CITY OF NEWPORT BEACH PLANNING COMMISSION STAFF REPORT

December 7, 2017
Agenda Item No. 5

SUBJECT: Ginsberg Residence (PA2016-170)

SITE LOCATION: 2607 Ocean Boulevard

GARAGE LEVEL FLOOR PLAN

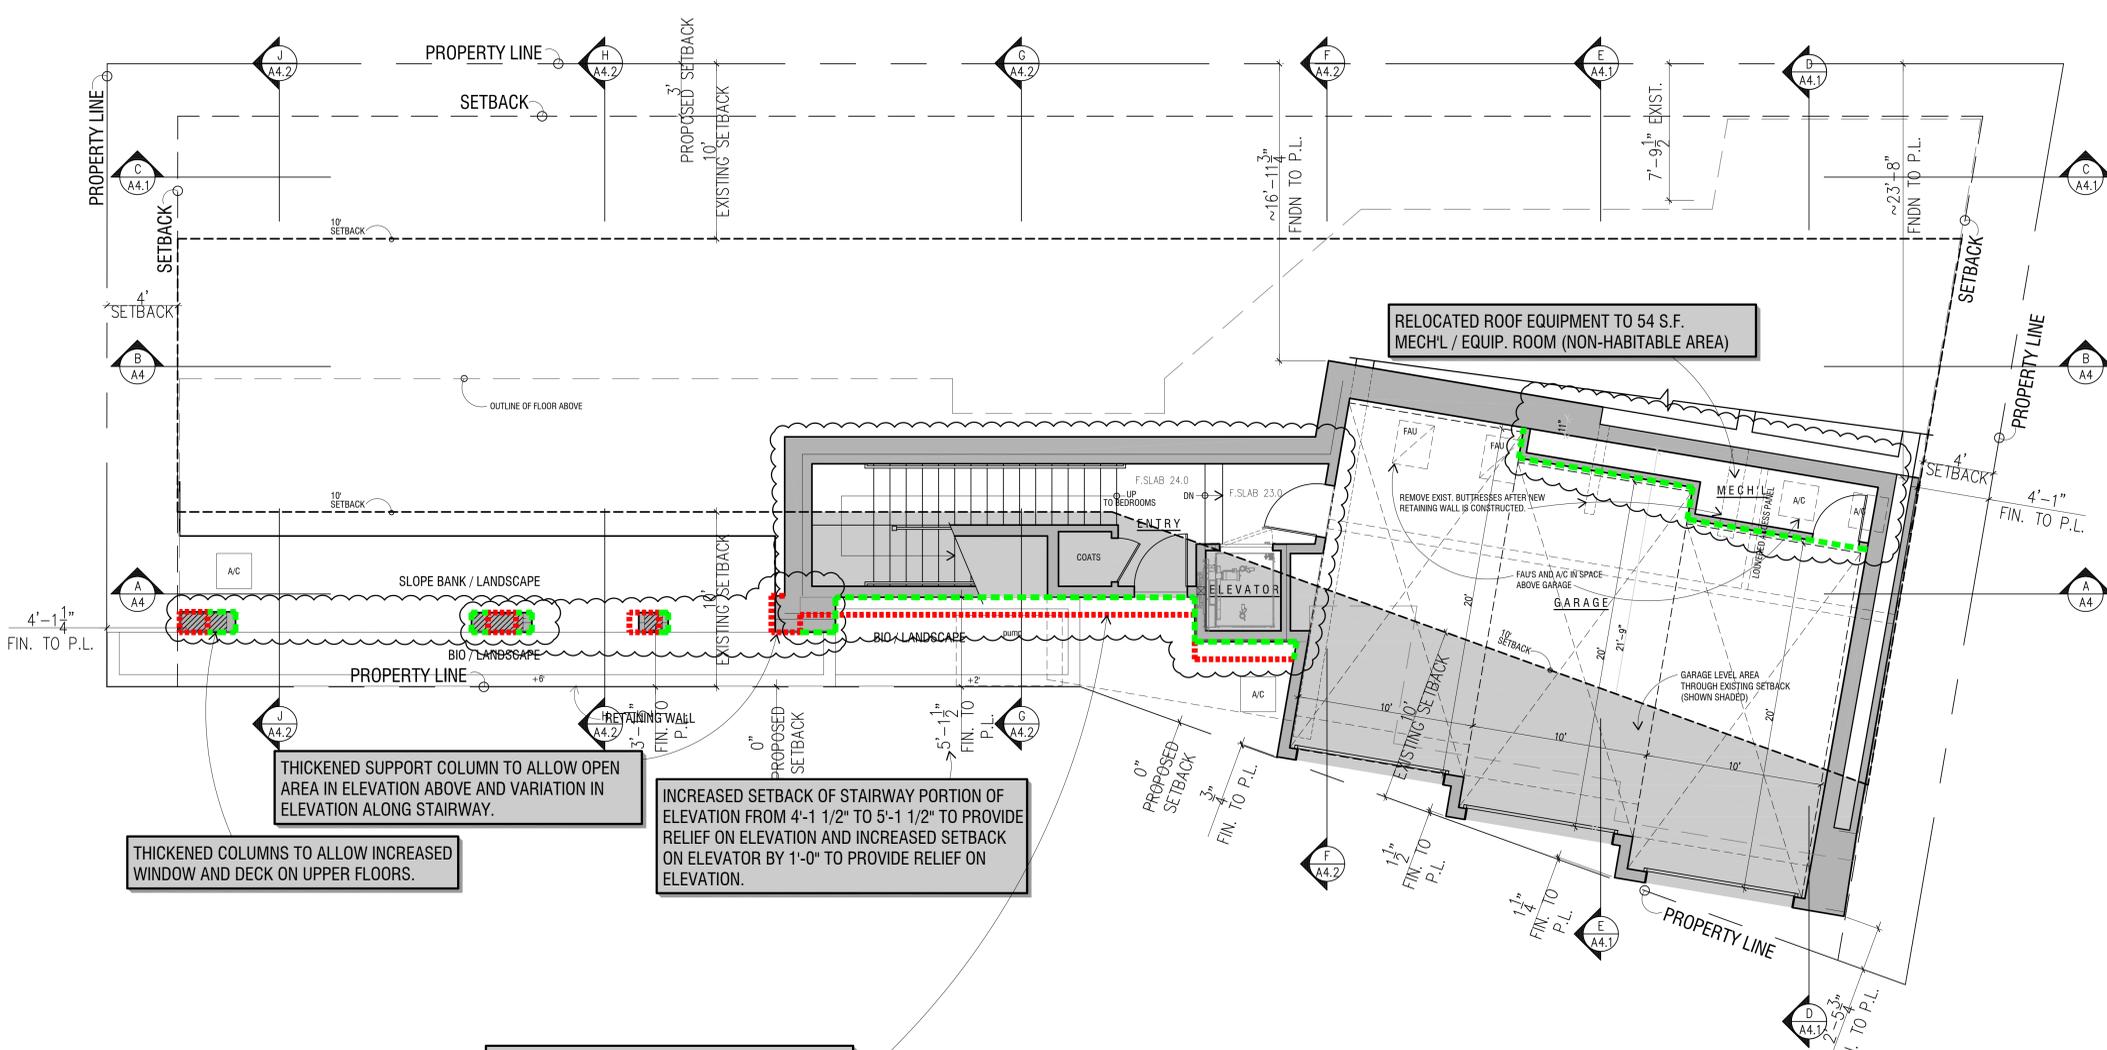
INCREASED SETBACK OF STAIRWAY PORTION OF ELEVATION FROM 4'-1 1/2" TO 5'-1 1/2" TO PROVIDE RELIEF ON ELEVATION AND INCREASED SETBACK ON ELEVATOR BY 1'-0" TO PROVIDE RELIEF ON ELEVATION.

BEDROOM LEVEL FLOOR PLAN

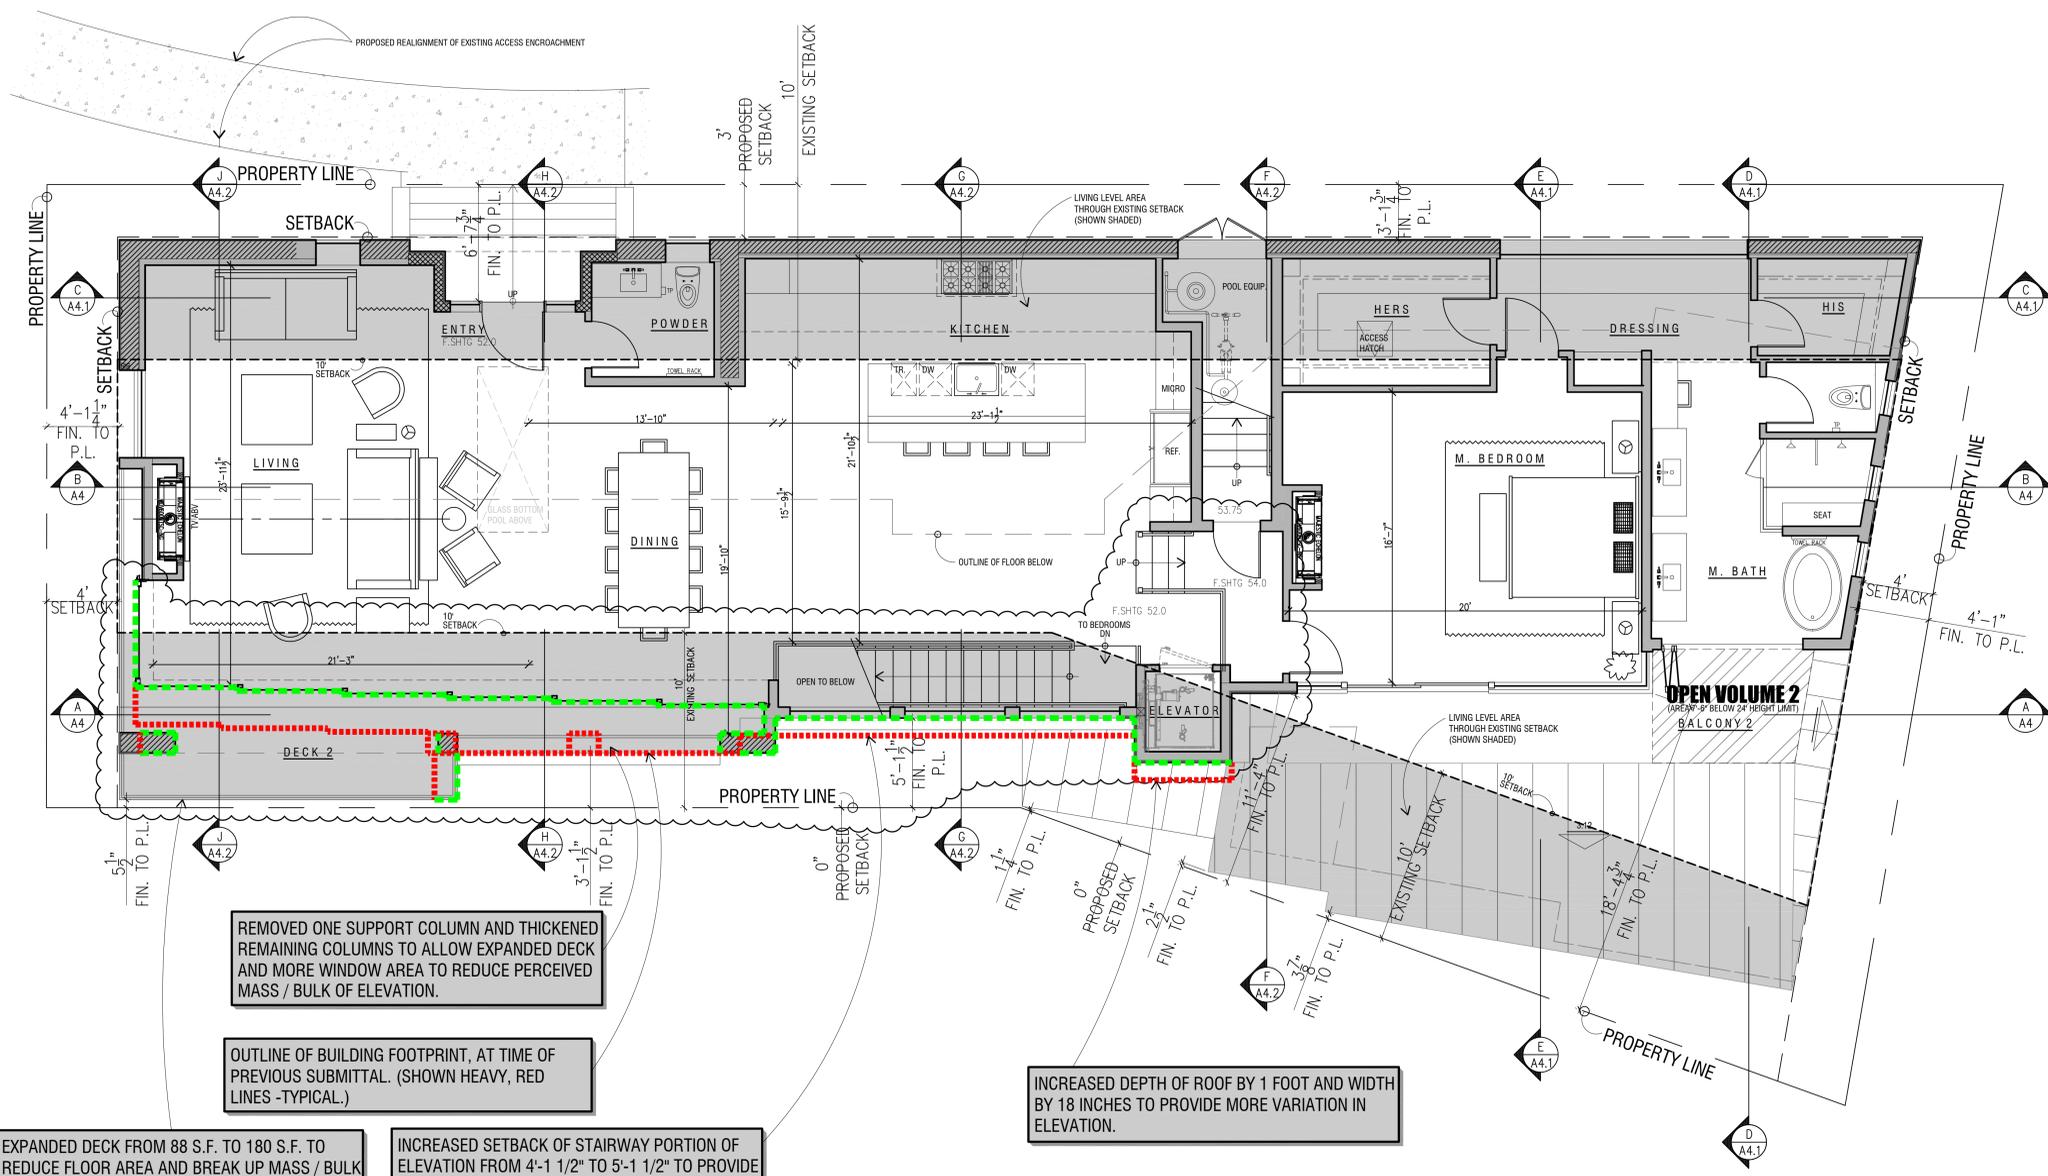
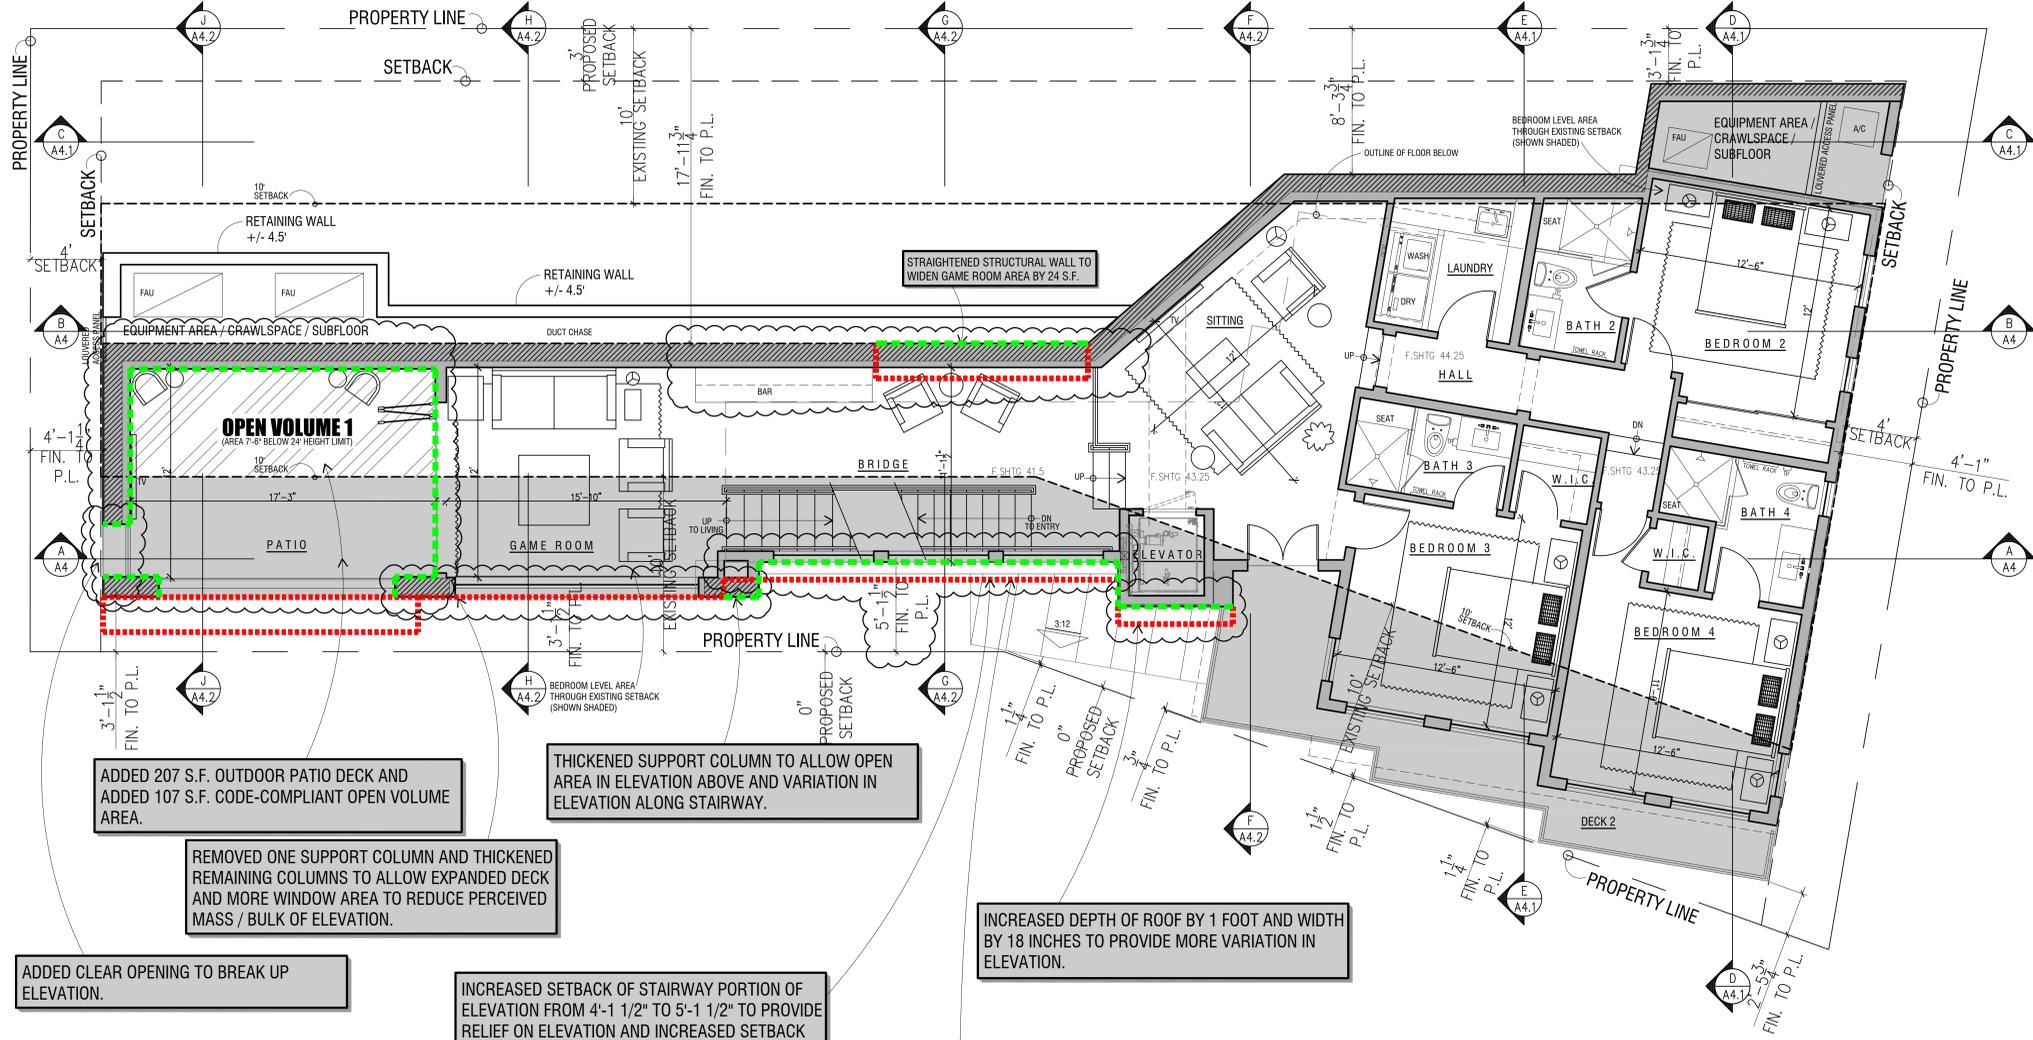
REMOVED ONE SUPPORT COLUMN AND THICKENED REMAINING COLUMNS TO ALLOW EXPANDED DECK AND MORE WINDOW AREA TO REDUCE PERCEIVED MASS / BULK OF ELEVATION.

ADDED CLEAR OPENING TO BREAK UP ELEVATION.

INCREASED SETBACK OF STAIRWAY PORTION OF ELEVATION FROM 4'-1 1/2" TO 5'-1 1/2" TO PROVIDE RELIEF ON ELEVATION AND INCREASED SETBACK ON ELEVATOR BY 1'-0" TO PROVIDE RELIEF ON ELEVATION.

INCREASED DEPTH OF ROOF BY 1 FOOT AND WIDTH BY 18 INCHES TO PROVIDE MORE VARIATION IN ELEVATION.
